E4980A-02B-S

S E R V I C E N O T E

E4980A Precision LCR Meter 20 Hz to 2 MHz

POSSIBLE SHOCK HAZARD

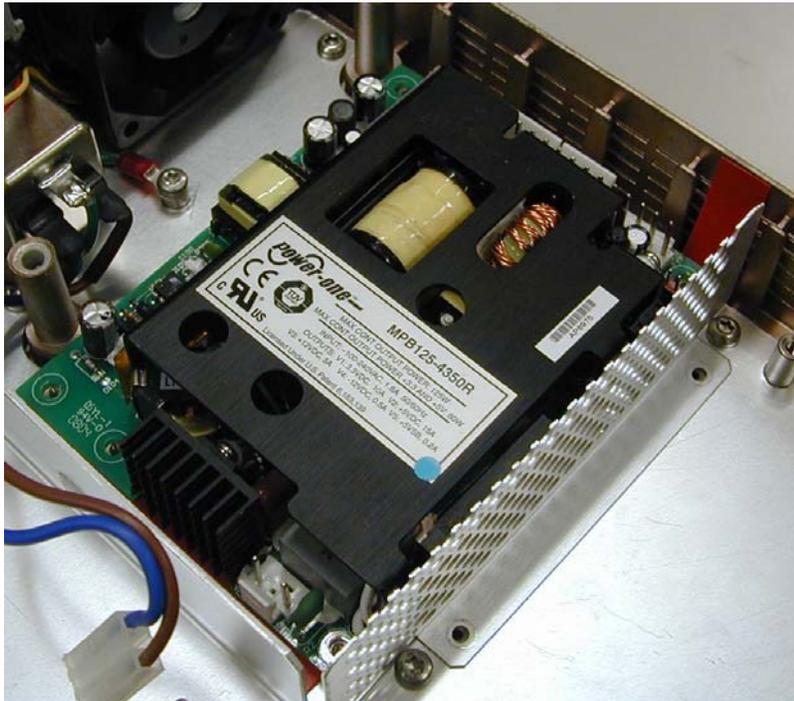
Step2. Put the insulator on base plate as shown in the figure below.

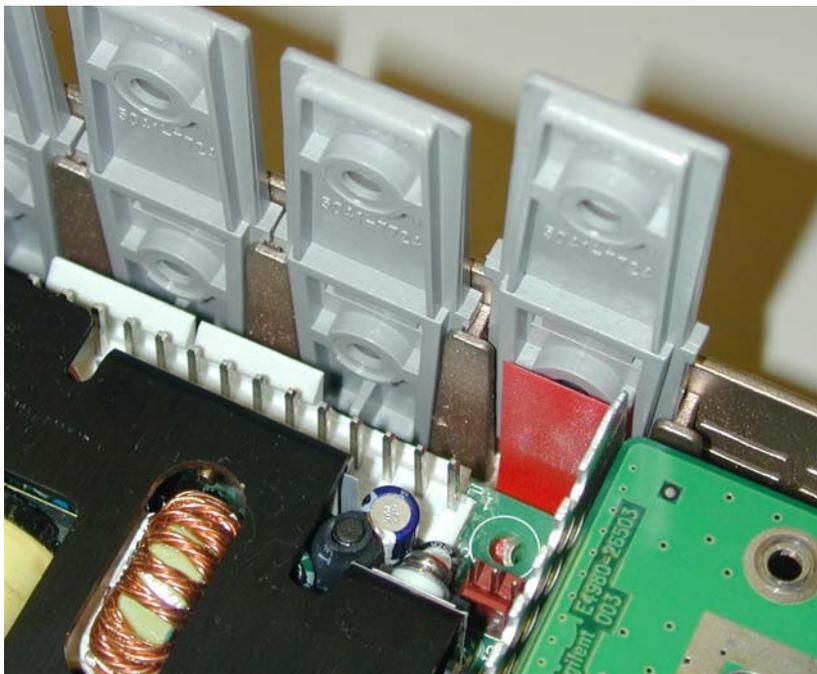
Step3. Place the power supply on the insulator. After fastening the power supply, remove the film of adhesive tape of the insulator. Then , fasten ANGLE SHIELD (E4980-01205) and stick the adhesive part of the insulator to the ANGLE SHIELD.

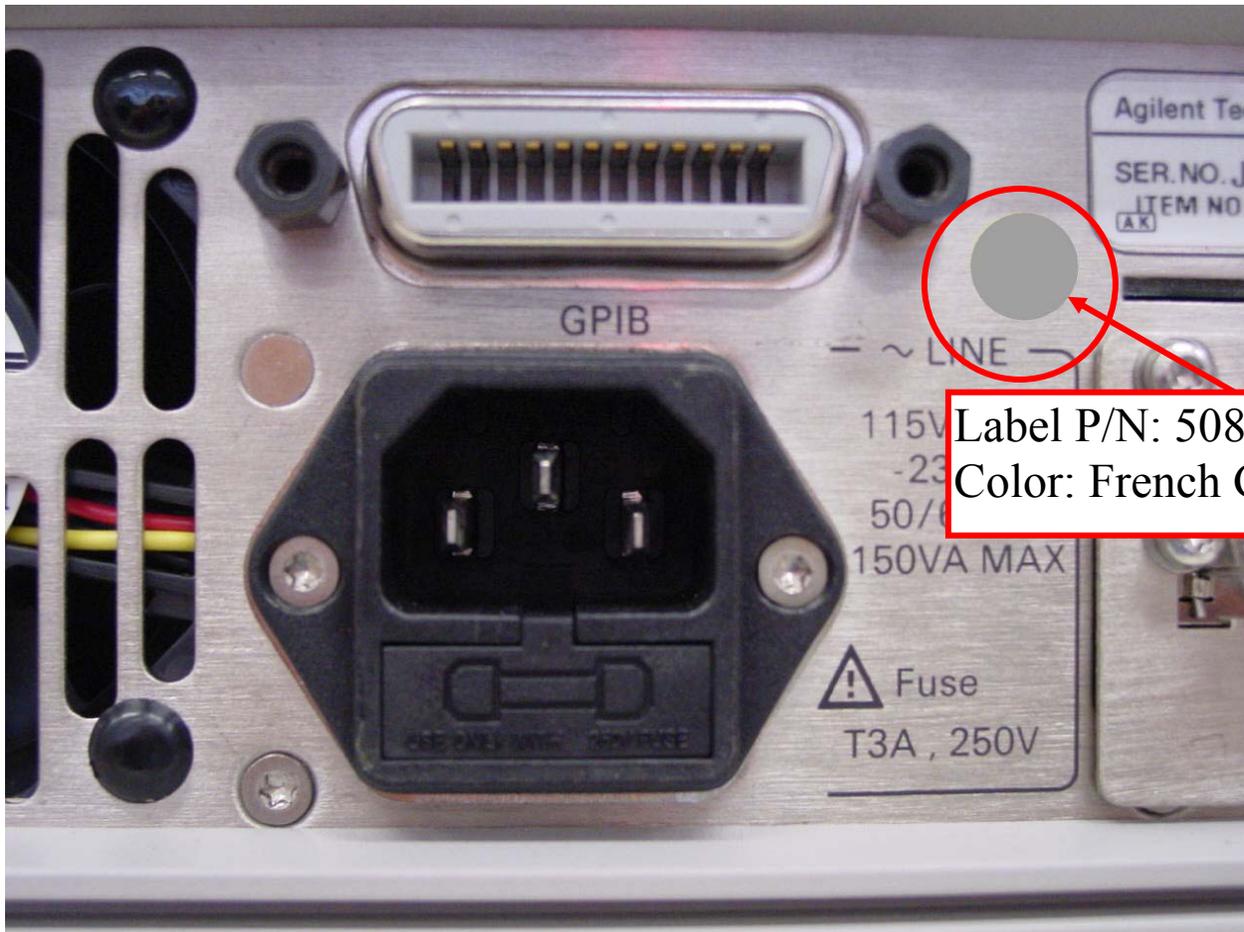
Step8. Stick a label (P/N 5080-3270) between AC Inlet and Serial Number Label. □See the place below□
